CERTIFICATE OF APPROPRIATENESS

Property: 202 E 10th Street, Tracts 23A and 24A, Block 229, Houston Heights Subdivision. The property includes a historic 2,695 square foot two-story wood frame single-family residence and a detached garage situated on an 8,200 square foot (82' x 100') corner lot.

Proposal: Alteration – Windows/Siding

Recommendation: Partial Approval: Approval to replace rotten sills and trim; Approval to replace windows 1, 2, 7, 9, 10, 17, 18, 37 and 40; Denial to replace all other windows.

FIRST FLOOR PLAN

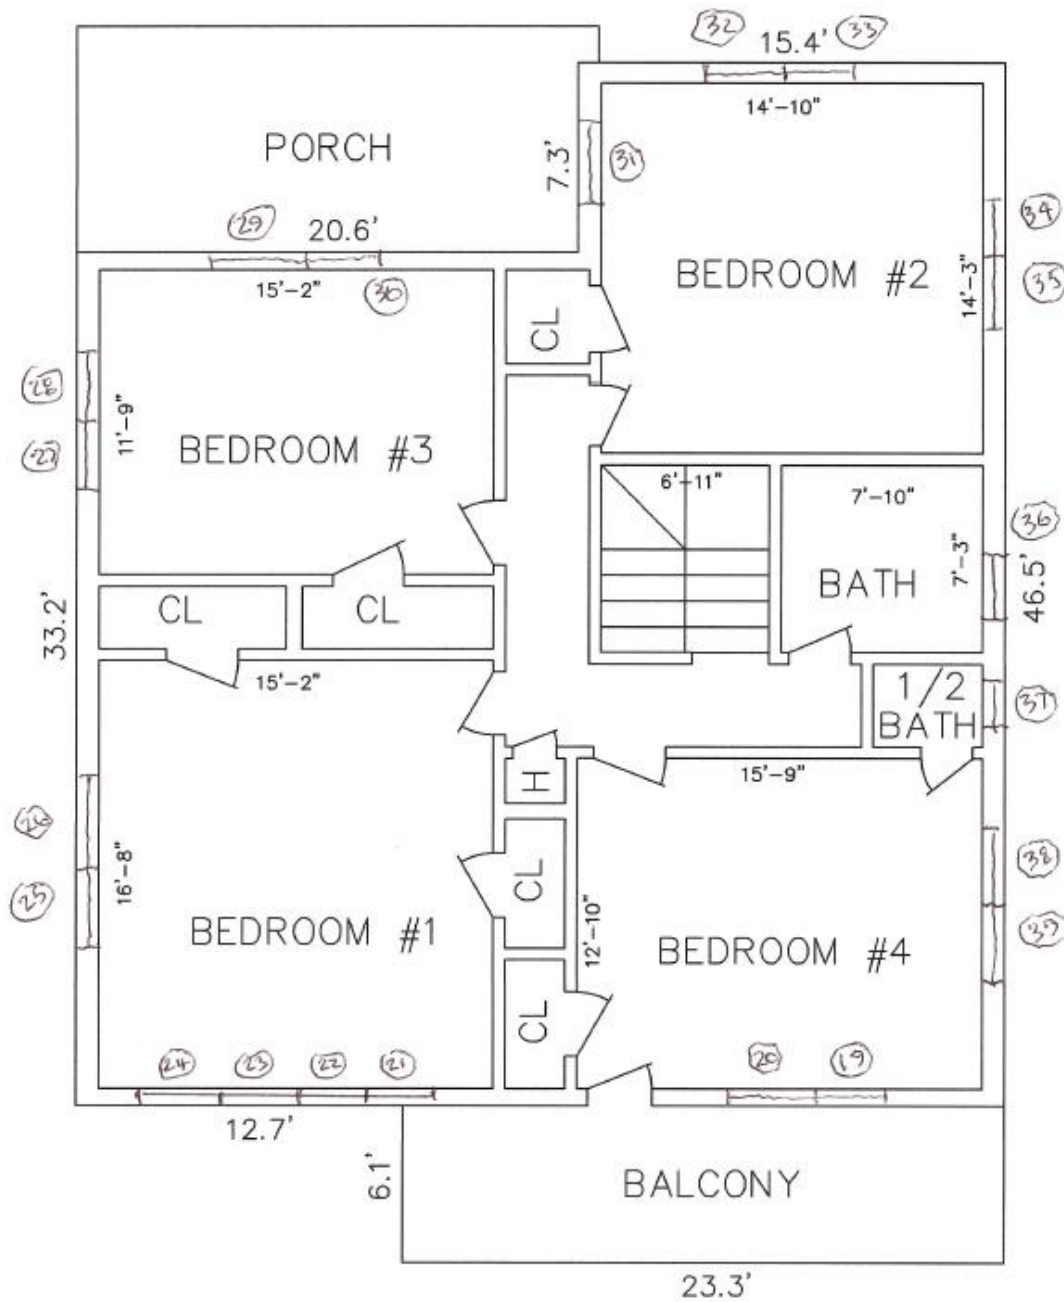
(North) Windows 15 and 16: no visible damage;

Window 17: Sill rotted, trim rotting, bottom rail of top sash falling out, bottom rail bottom sash soft, framing warped;

Window 18: Sill and trim rotting, window unit bent the bottom rail of the bottom sash, framing warped;

(West) Window 11: Sill and trim rotting, bottom rail of bottom sash soft;

Window 6: Sill rotted;

Window 7: Sill rotted, bottom rails rotted, stiles are soft;

Window 9: Sill and trim rotting, multiple soft parts, top sash repaired previously with metal bracket;

Window 10: Sill and trim rotting, multiple soft parts, top sash repaired previously with metal bracket;

Window 40: Sill and trim rotting, multiple soft parts, framing warped;

(South) Window 1: Frame bent from window unit, bottom rail of top sash missing, bottom rail of bottom sash rotten and bent stiles bent;

Window 2: Frame warped, bottom rail of bottom sash rotten, sill rotten, bottom rail of top sash rotten, stiles are soft;

HAHC Action: Partially Approved: Approval to replace rotten sills and trim; Approval to replace windows 1, 2, 7, 9, 10, 17, 18, 37 and 40; Denial to replace all other windows.

PHOTOS OF SIDING

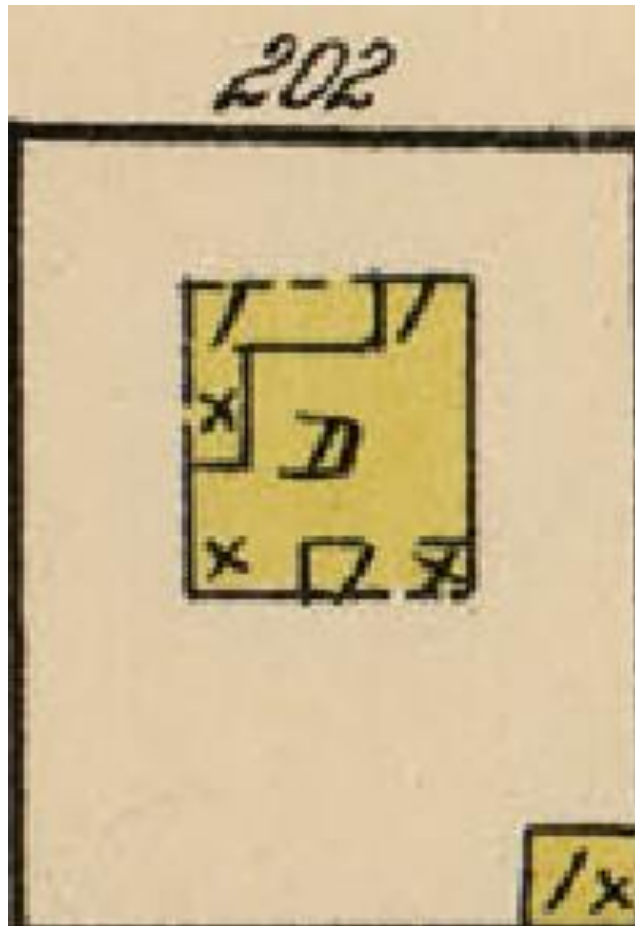
A spot check confirmed the presence of siding underneath the vinyl and asphalt, until the other materials are fully removed to see if any damage is present, the wood siding should be retained and repaired.

Exterior Materials: The residence is clad in wood 105 siding that is covered by a layer of asphalt shingles, and then again with vinyl siding. The alteration removes all siding and installs new 5" reveal cementitious lap siding.

Approval to remove vinyl and asphalt siding; Denial to remove wood siding and replace with cementitious siding.

Approval to remove vinyl and asphalt siding; Denial to remove wood siding and replace with cementitious siding.
